Paradise Ranch
Land Owners Association, Inc
P. O. Box 2426
Victoria, TX 77902

December 13, 2008

Re: Exelon's Victoria County, Texas Application

Figure 3.1-9 Total Land to be Developed

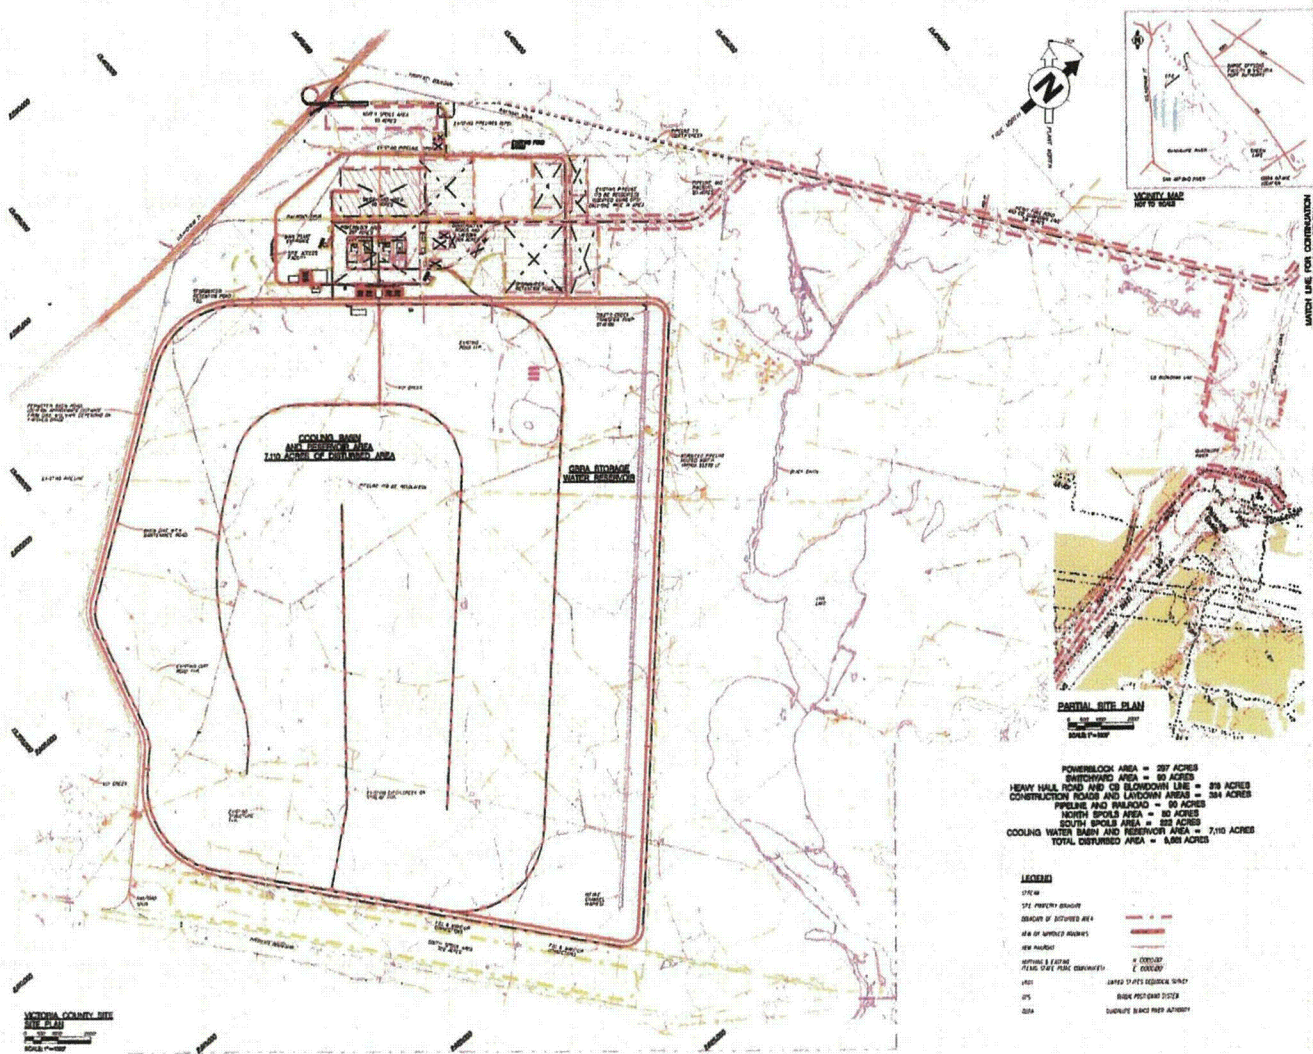
Exelon has also identified our property to have the majority of the Heavy Haul Road located across it. The proposed roadway is directly across our existing ingress and egress easement road from Hwy 77 South. In addition to our Ranch there are two other ranches known as the Gibbs and Stubblefeild ranches that also use the easement road. Exelon did

not address anything about our access in their application. We were told by Exelon representatives at our homeowners meeting that we would not be allowed to use the Heavy haul road for approximately 10 years. On any given day there are 25 to upwards of 200 people on the three ranches. We have included a map from Chapter 3 of the permit application with our notations so that you may better understand our positions and concerns.
